SECTION 4.55 DA
MODIFICATION

URBNSURF SYDNEY
SYDNEY OLYMPIC PARK, NSW

SECTION 4.55 DA MODIFICATION

Aerial View - Proposed Site Plan
Scale 1 : 500

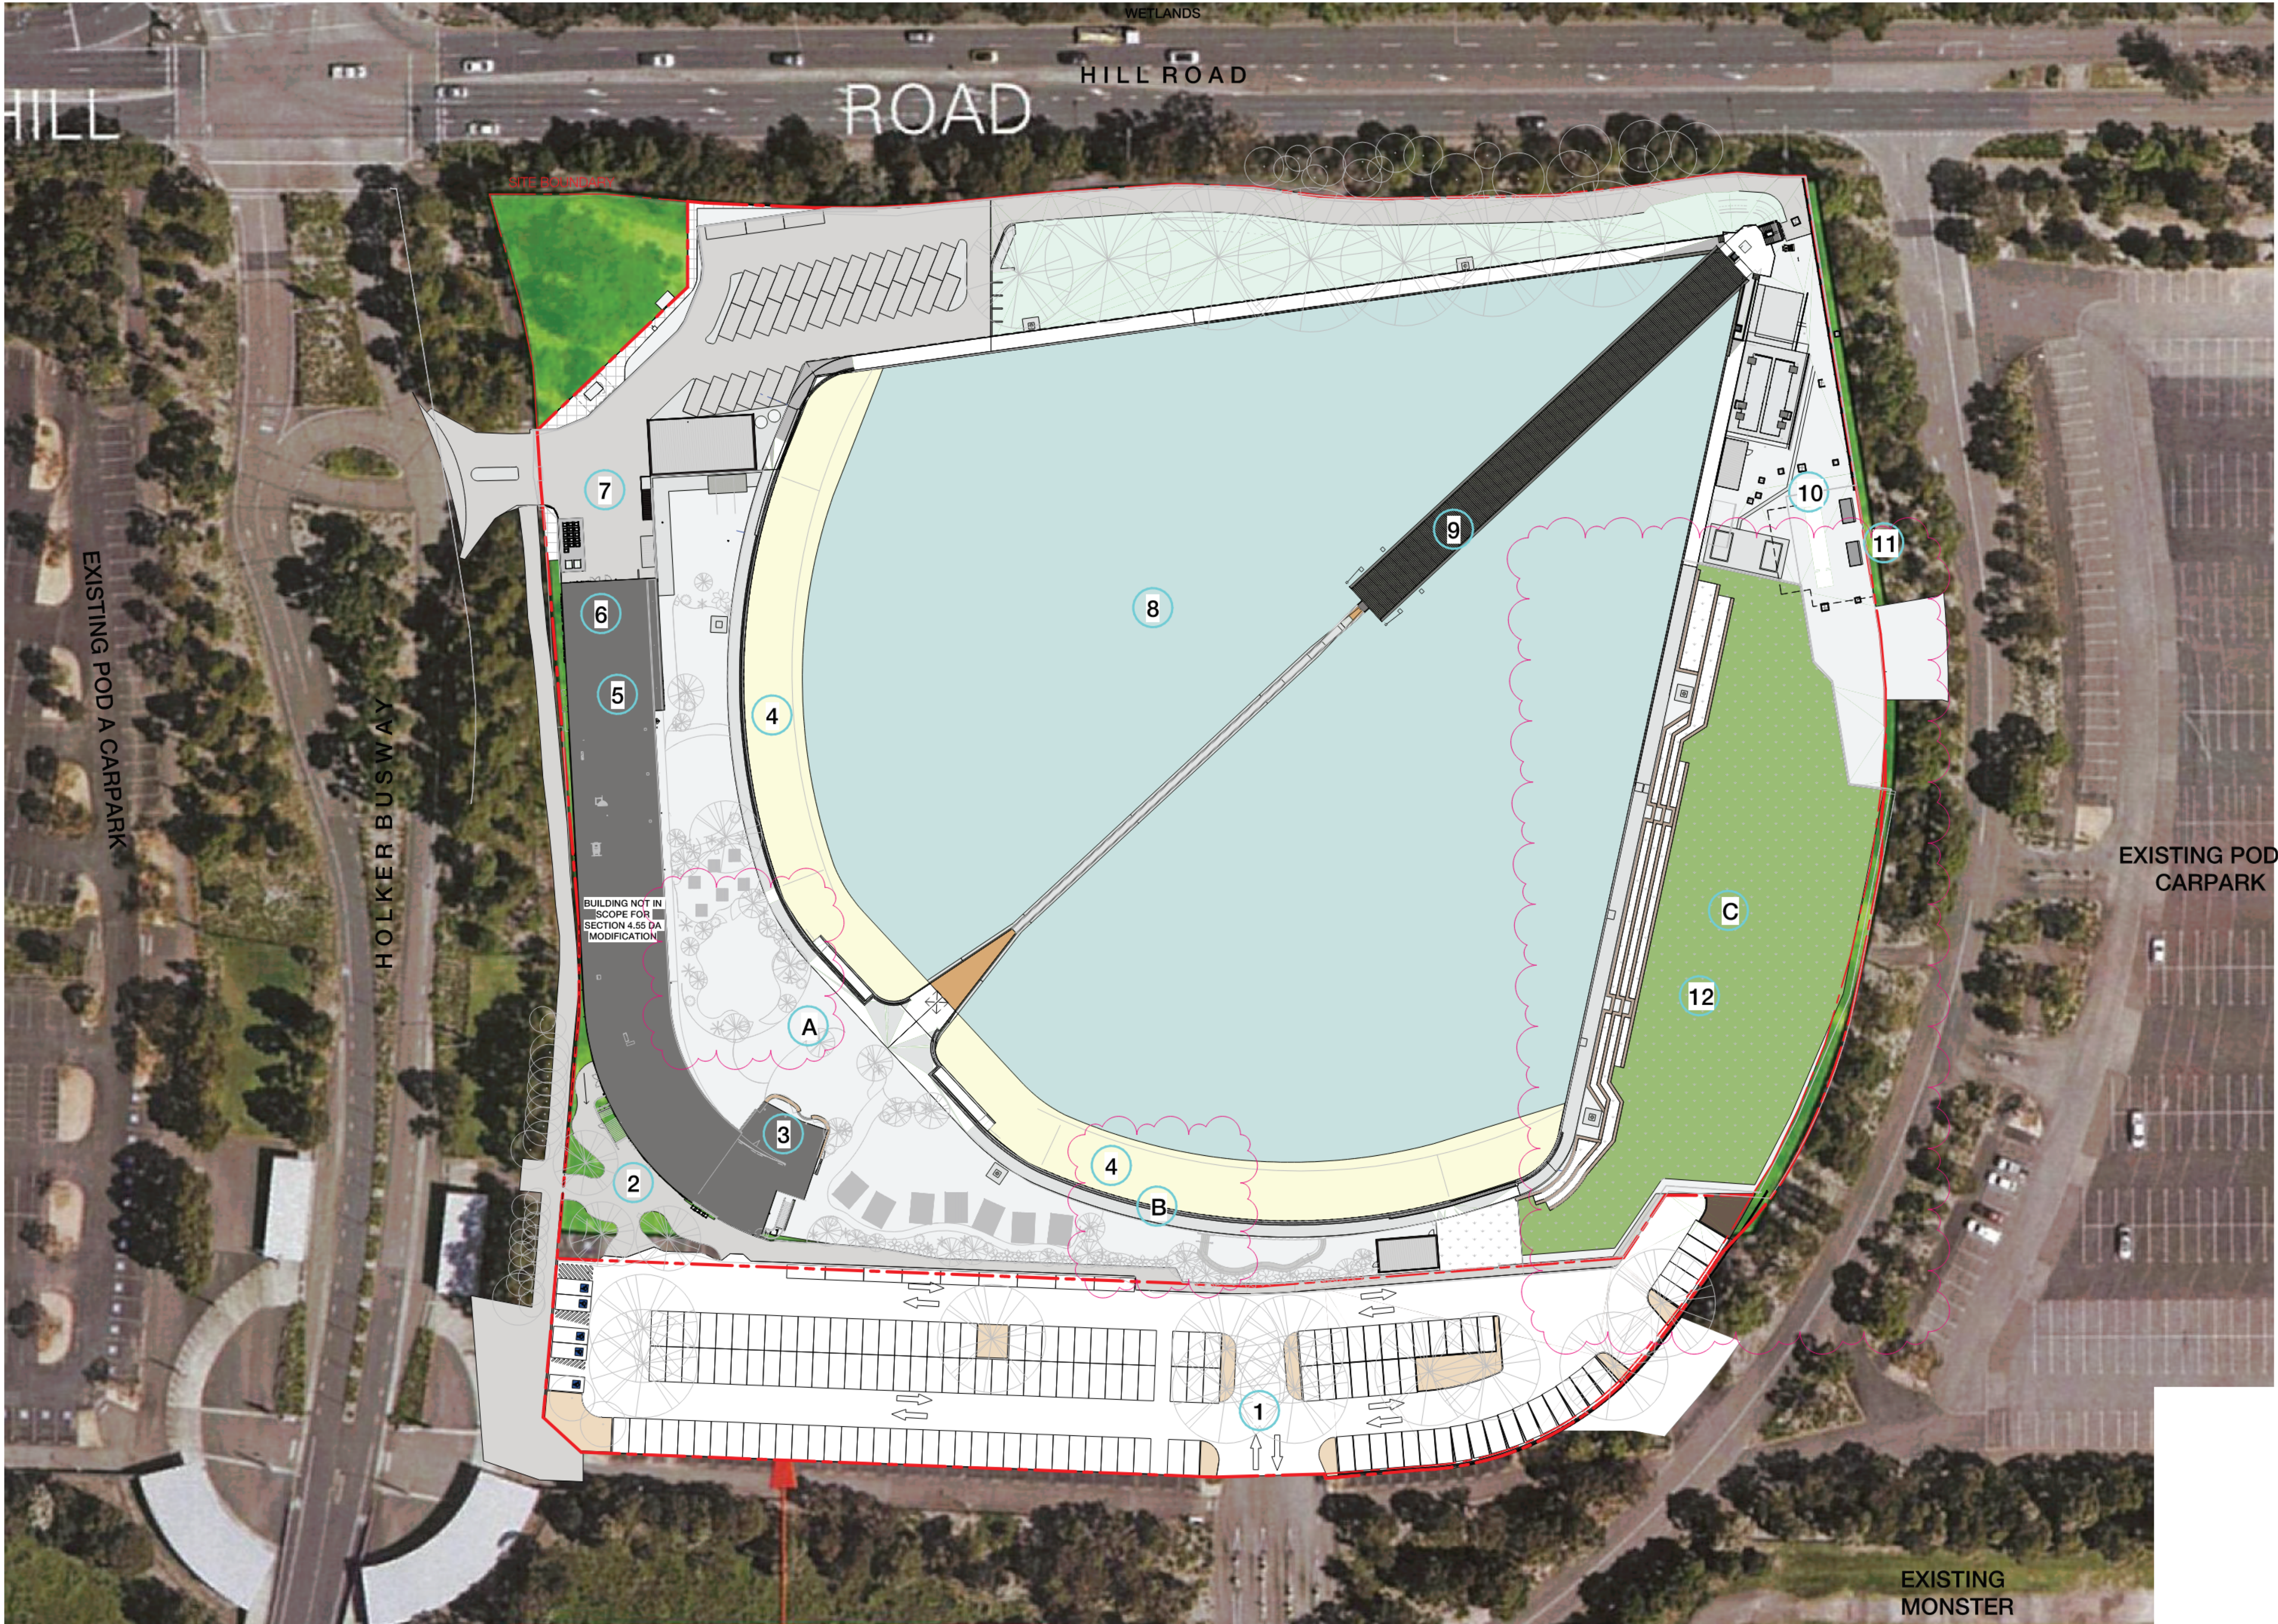
- A Design Change 1: Playground area replaced with lawn space (Landscape)
- B Design Change 2: Kids pool replaced with lawn space (Landscape)
- C Design Change 3: Revised Eastern Hill landscape design

Proposed Site Plan
Scale 1 : 500

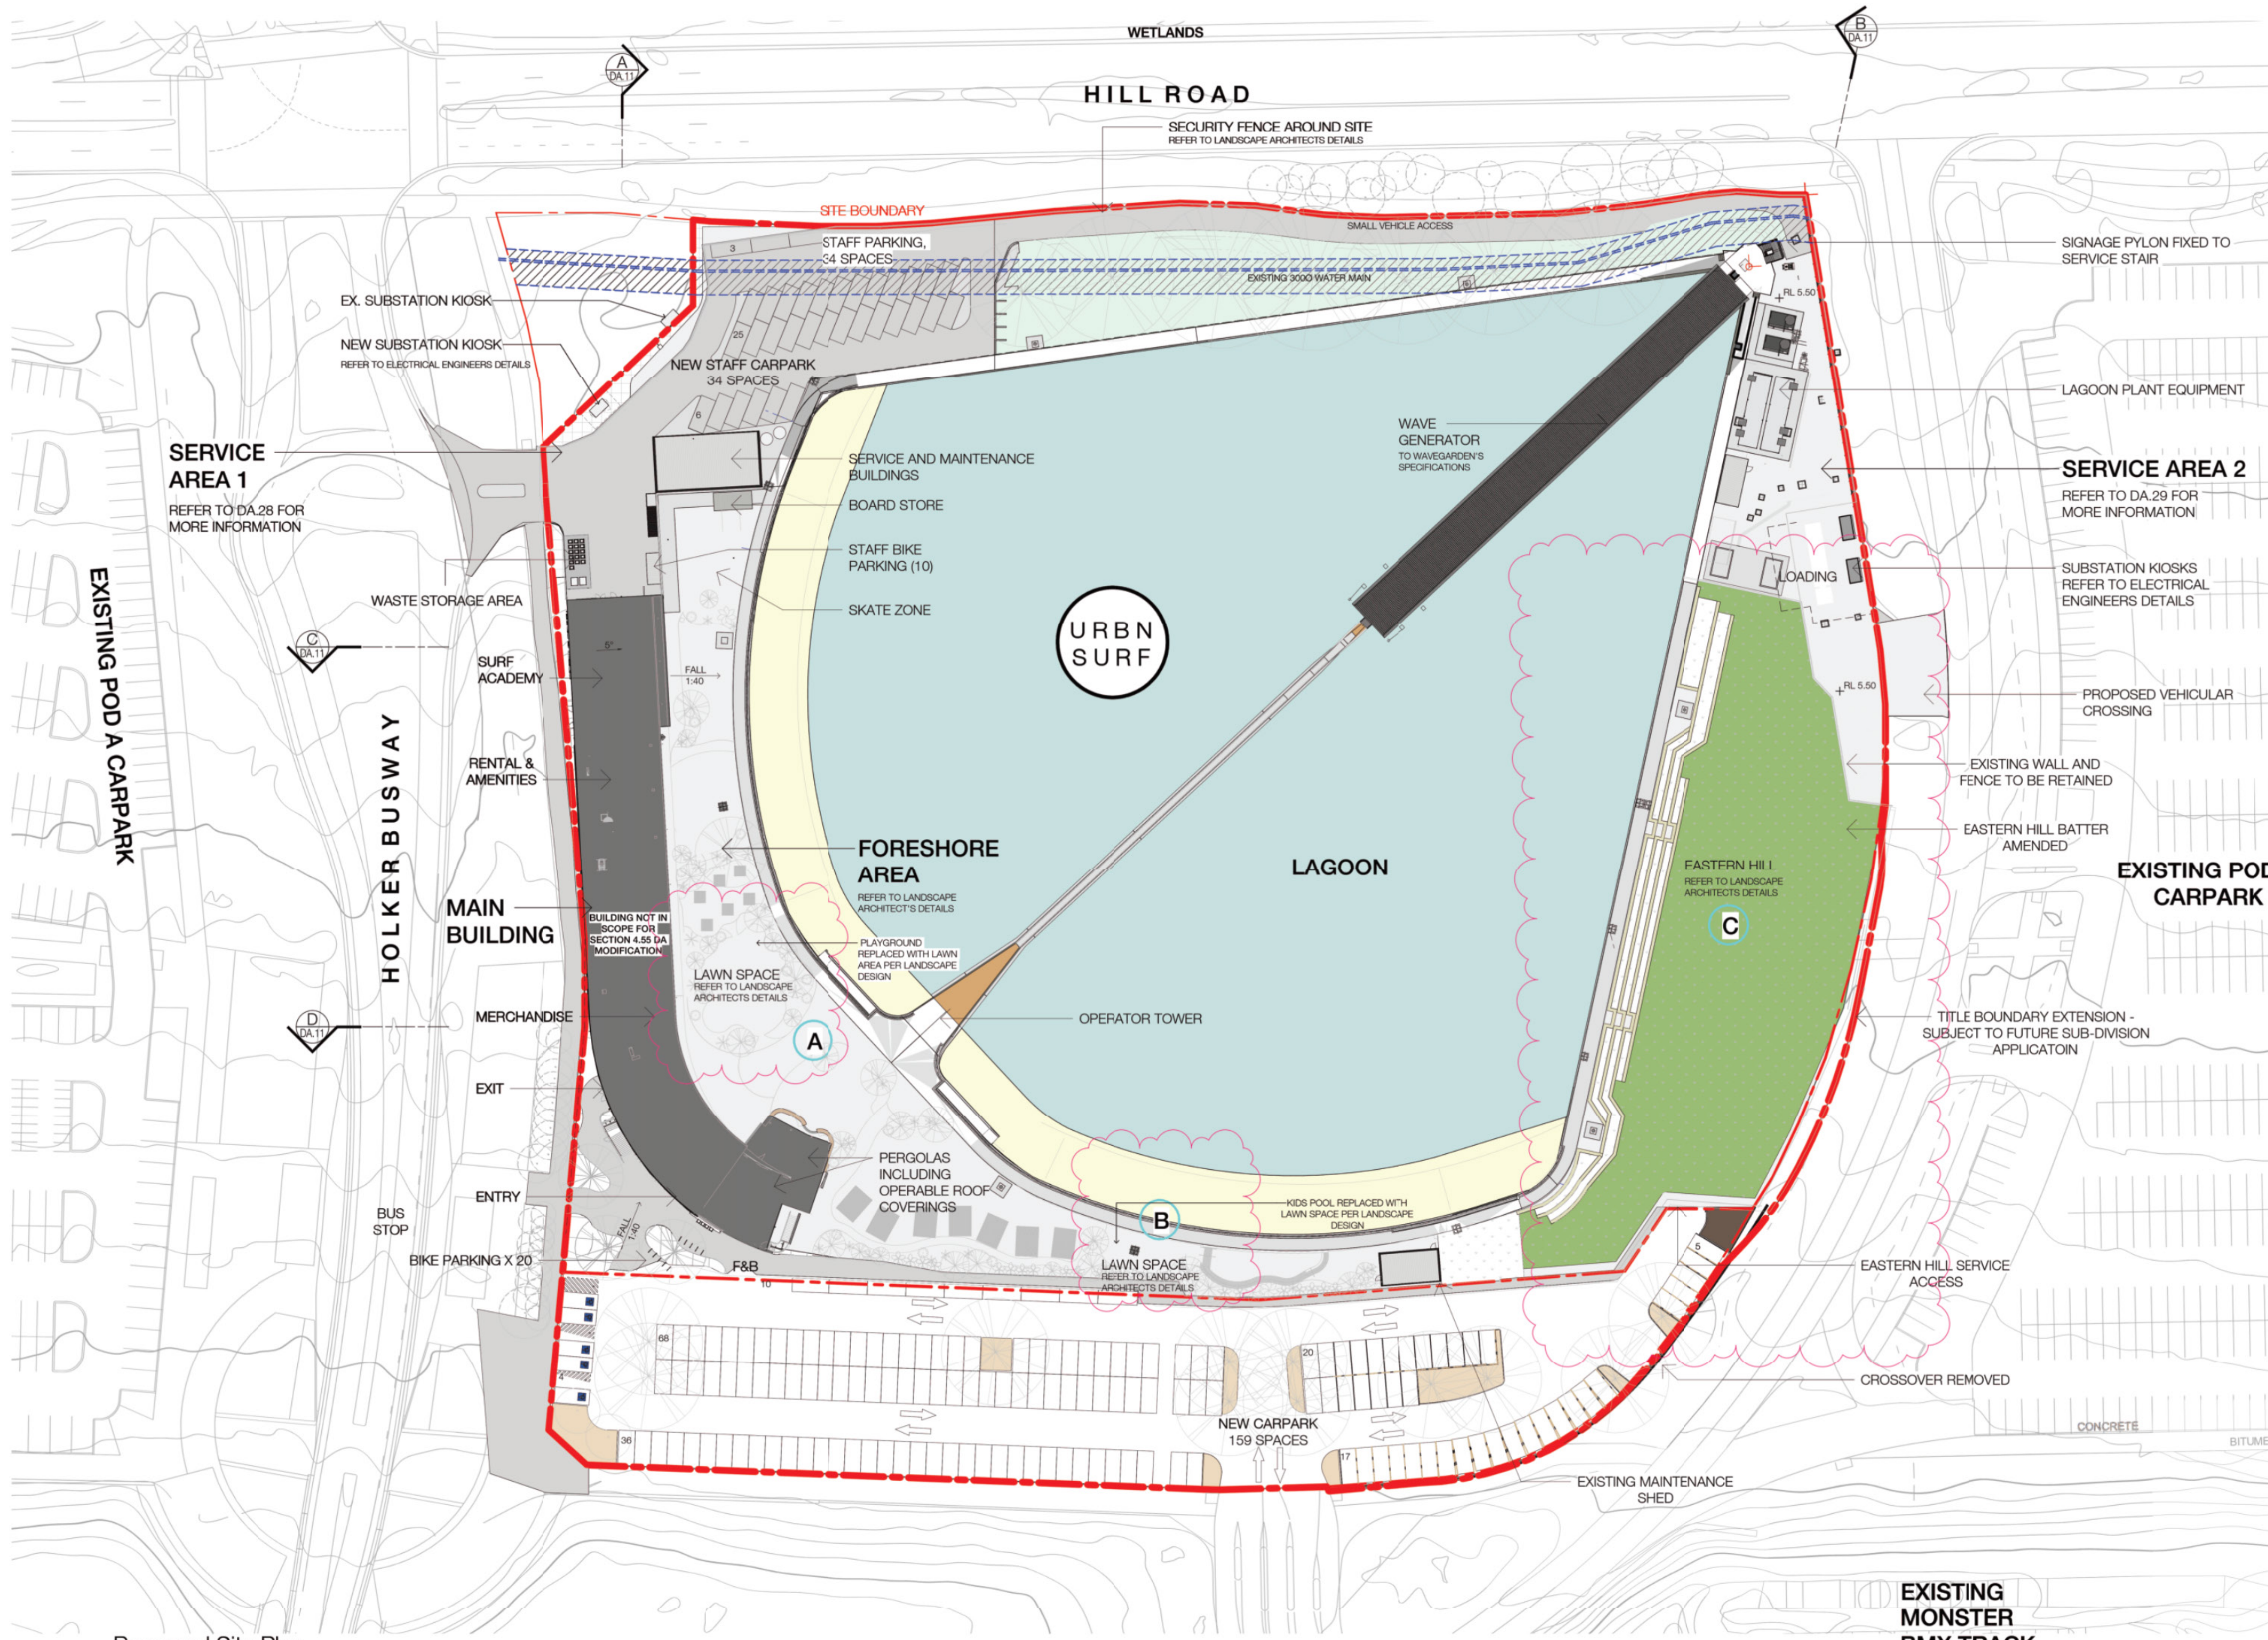
- A** Design Change 1: Playground area replaced with lawn space (Landscape)
- B** Design Change 2: Kids pool replaced with lawn space (Landscape)
- C** Design Change 3: Revised Eastern Hill landscape design

A - SITE SECTION
Scale 1 : 500

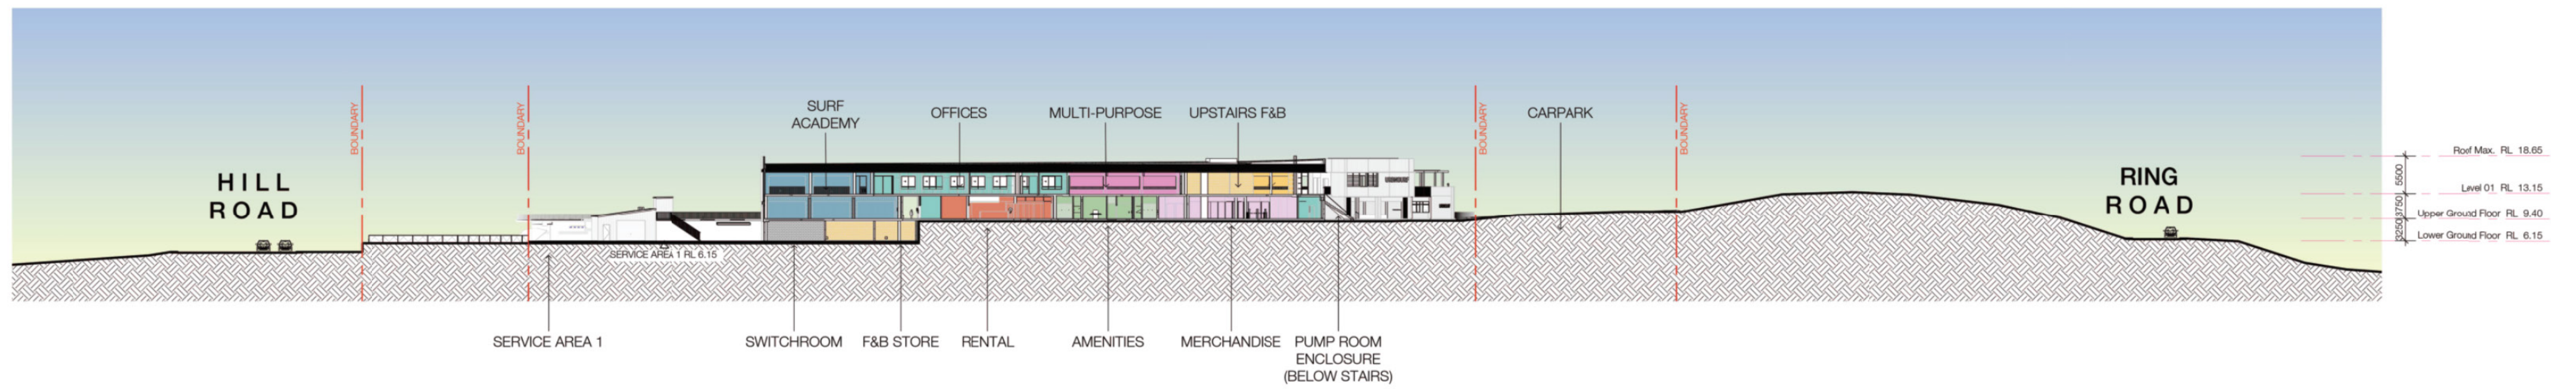
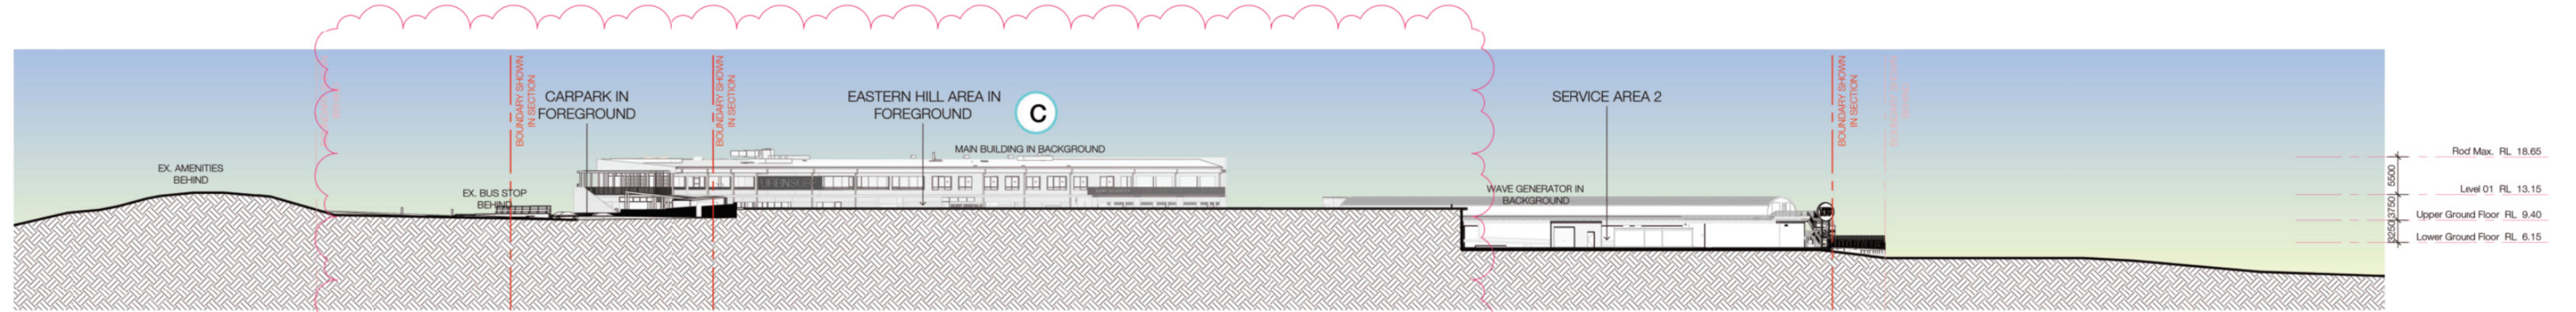
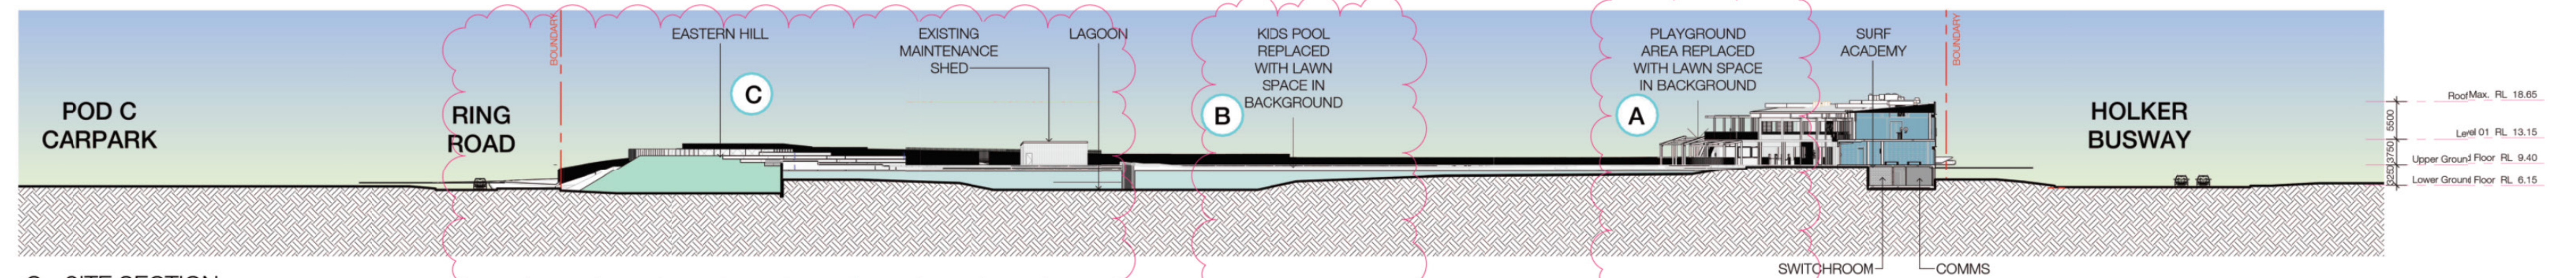
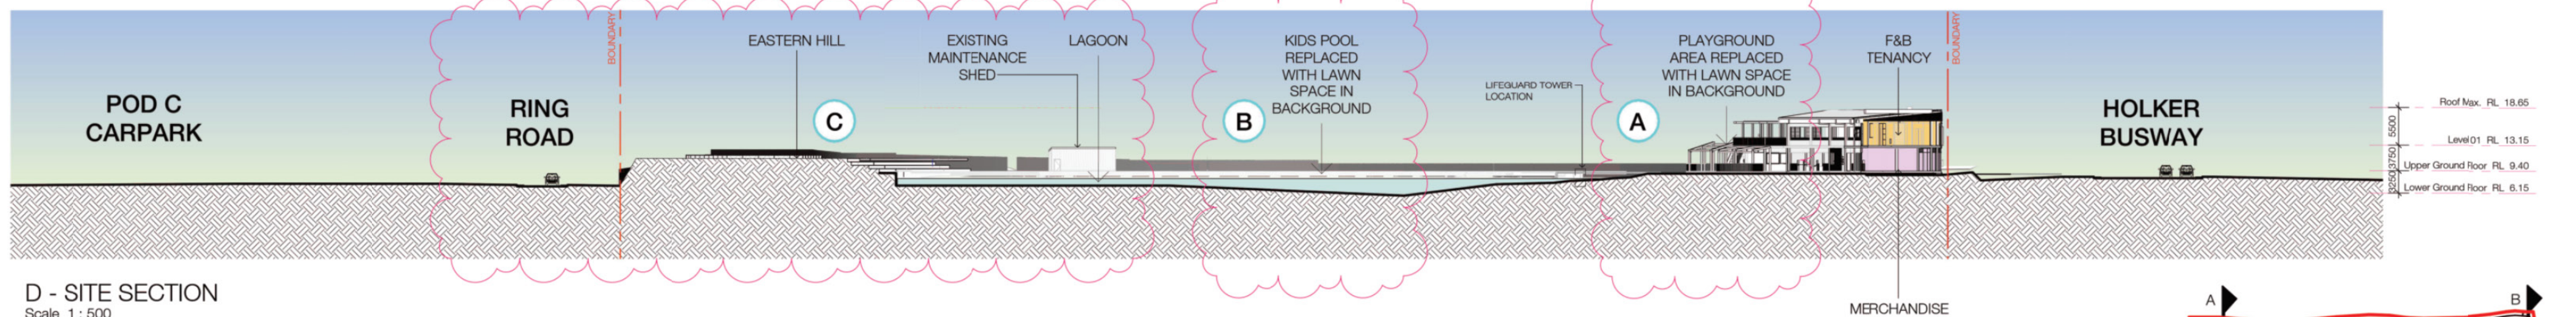
- A** Design Change 1: Playground area replaced with lawn space (Landscape)
- B** Design Change 2: Kids pool replaced with lawn space (Landscape)
- C** Design Change 3: Revised Eastern Hill landscape design
